TECHNICAL INFORMATION

- Subject** ▶ Modification of Housing Set and Set Plate, Addition of Wrench Holder 3.4
- For Models** ▶ 6831D
- Country** ▶ All countries
- Description** ▶ Housing set and Set plate has been modified. Wrench holder 3.4 has been added. See illustrations for the details.

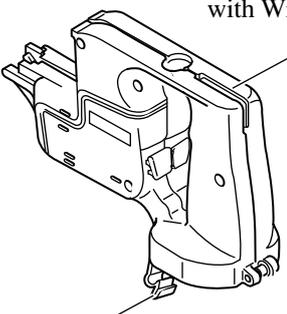
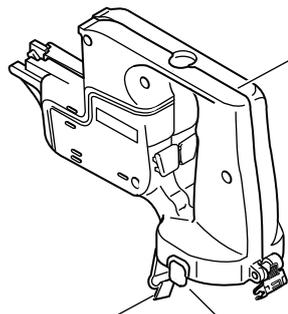
▶ Current	▶ New
<div style="text-align: center;">  <p>Housing set (182658-8) with Wrench holder</p> </div> <div style="margin-top: 20px;">  <p>Set plate (344121-1) 14.0mm (9/16")</p> <p>This Housing set does not allow you to use push button type battery.</p> </div>	<div style="text-align: center;">  <p>Housing set (183169-6) without Wrench holder</p> </div> <div style="margin-top: 20px;">  <p>Set plate (343579-1) 10.5mm (13/32")</p> <p>The claws on housing set allow you to use push button type battery.</p> </div> <div style="border: 1px dashed black; padding: 10px; margin-top: 20px;"> <p style="text-align: center;">How to install Wrench holder 3.4 into the new Housing set</p> <p>Put the tail of Wrench holder 3.4 through the slit on the foot of Housing set. </p> <p>Bend Wrench holder 3.4 and put the tail of Wrench holder 3.4 through the slot to fix it with Housing set. </p> </div>

Item No.	Current part	Q'ty	I/C	New part	Q'ty	Note
002, 048	Housing Set 182658-8	1	No	Housing Set 183169-6	1	Interchangeable as a set
006	Set Plate 344121-1	1	No	Set Plate 343579-1	1	
A06				Wrench Holder 3.4 410048-8	1
